Part (2) A – Wharfe Meadows, Titty Bottle and Manor Parks

1. Site Specific Recommendations

1.1 Summary of Rationale for Recommendations

Titty Bottle Park Fencing

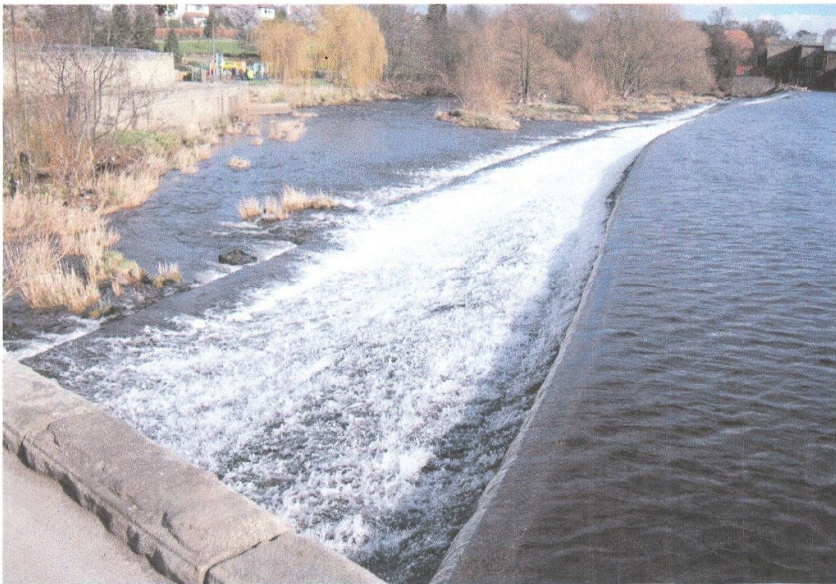
- *It is recommended that you take action to cut the trees over hanging the river, which act as a magnet to children to climb over the water.*

Wharfe Meadows Park Weir in Low and High Water Levels

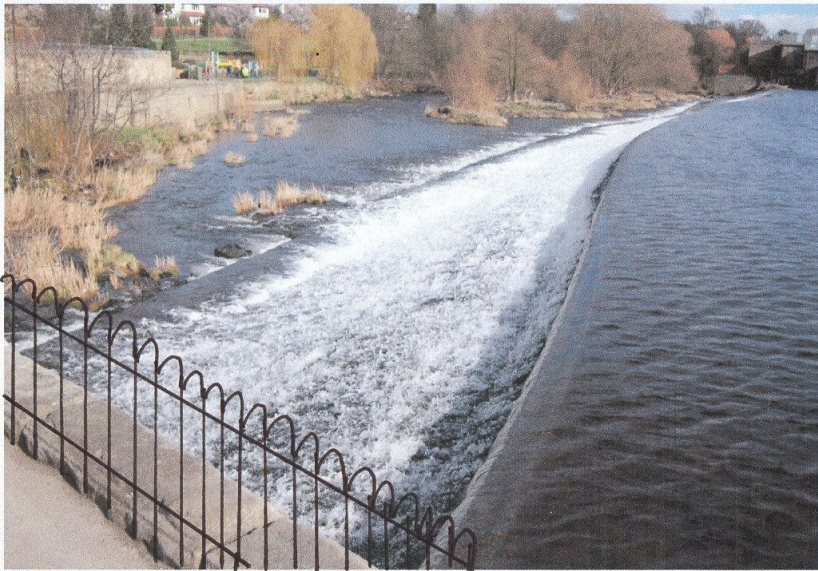
Edge protection is required and signage can be used to support water safety. This is an urban site and those that access the site from the playground and downstream expect the path to be a significant distance away from the water and where it is adjacent to the water it is currently fenced, we always strive to be consistent in our approach either there is open access or not, compromises and a mixed approach send out mixed safety messages. Tourists and those not familiar with the site would not be aware that when turning around the bend they would currently be met with an absence of fencing up to and beyond the weir.

A option version for an aesthetically more acceptable design to edge protection, would involve the positioning of fence lines along the existing low wall/coping stone top and encouraging the main pedestrian flow through the park where possible on pathways away from the waters edge. This design would allow for easier egress for canoeists so that they can get out of the river upstream and portage around the weir. There would still be a fence and the main walkway would be back from the river for those who do not want to expose themselves to the river and those that do make a conscious decision to do so by going to the stepped area aware of the hazard. This version would allow emergency and rescue service vehicles and watercraft to access the stepped area.

The specific location and detailing of the fencing and gates can be seen in the annotated photographs and site plans. The fencing would need to be a non-climb design such that already exists on site, the bow topped fencing meets the requirement. It is designed to stop deliberate access from those of 8 years and younger and accidental access by older children and adults.

Site Map

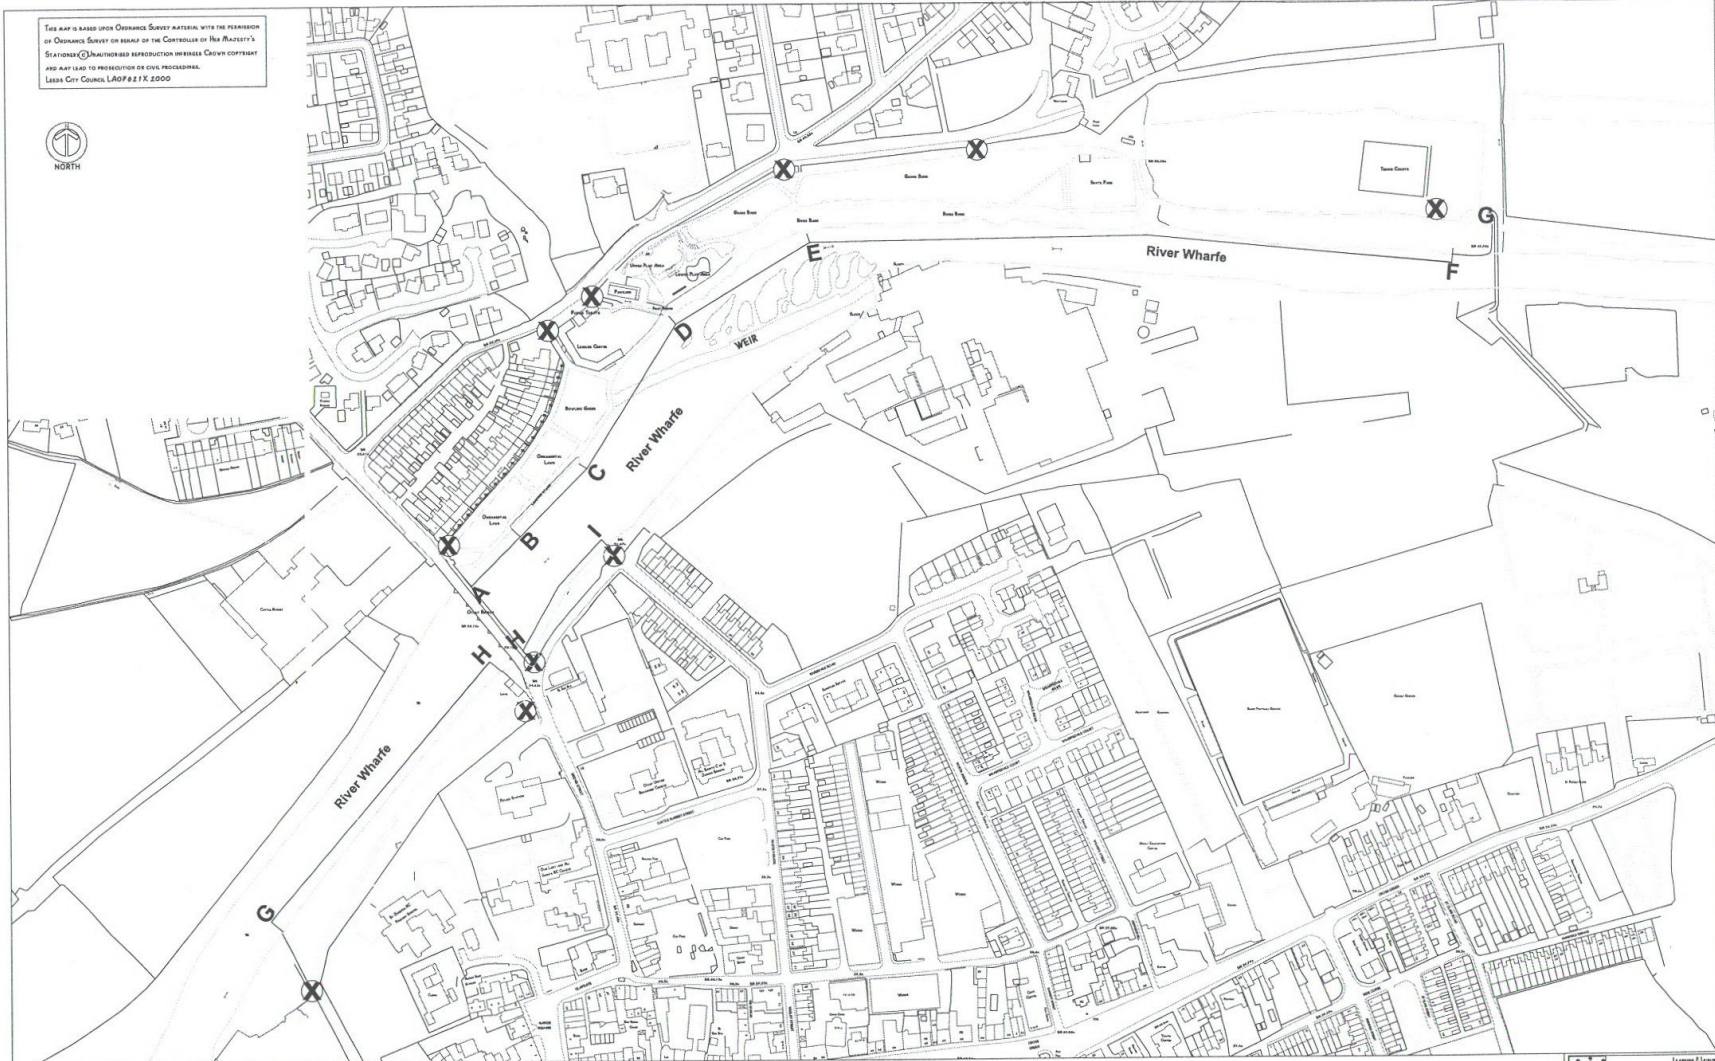
The rest of the walkway up to the concrete pad should be protected by urban bow top fencing again with suitable signage (this bow top fencing will link with the existing fencing). This level of fencing should be enhanced by a 2-meter area of unstrimmed vegetation to discourage access to the waters edge up to the white bridge.

- *It is recommended that ‘Multi points’ (see generic recommendations in section 6.3 above) be positioned at either end of the walkway. Positioned so the public can see them as they access the walkway.*

- *Repeat ‘nag sign’s should be positioned at regular intervals along the Urban Bow top fencing. (See recommendations for signage for **safety points** in section 6.3 above, although as previously recommended life saving equipment will not be provided)*
